Oregon Water Resources Department

REQUEST FOR WRITTEN APPROVAL TO USE CONSTRUCTION METHODS NOT INCLUDED IN OREGON ADMINISTRATIVE RULES 690-200 THROUGH 690-240

(1) Location of Well #3- NW SW #4- SE 1/4 NW 1/4 of Section 25

(7) Diagram showing the pertinent features of the proposed well design and construction (attach additional pages if needed):

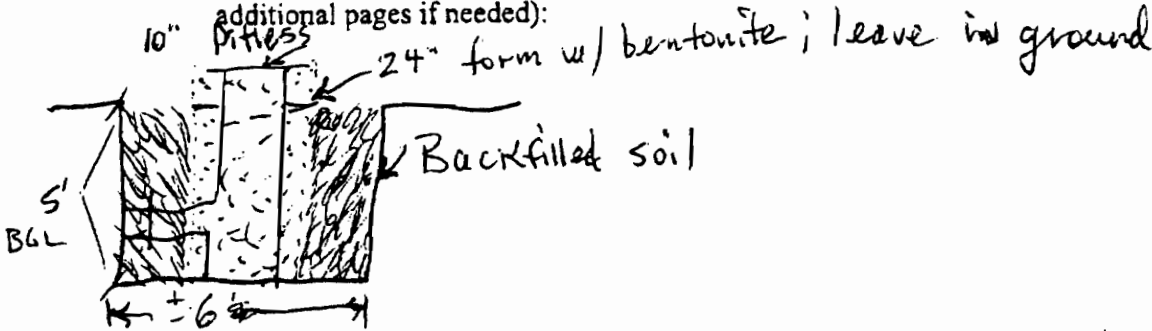
(5) The unusual conditions which necessitate this request: installation of a 10" weld-on pitless adapter necessitated a large pit around the casing to 5' BGL.

setting of a heavy cardboard cement-type form, 24" i.d., over the pitless & conduits, backfilling around the form with dirt & inside the form w/dry bentonite, leaving the form in the ground.

Date: 11/26/02
Approved by: David Jandt Denied by: _____
Remarks: Verbal approval given previously.
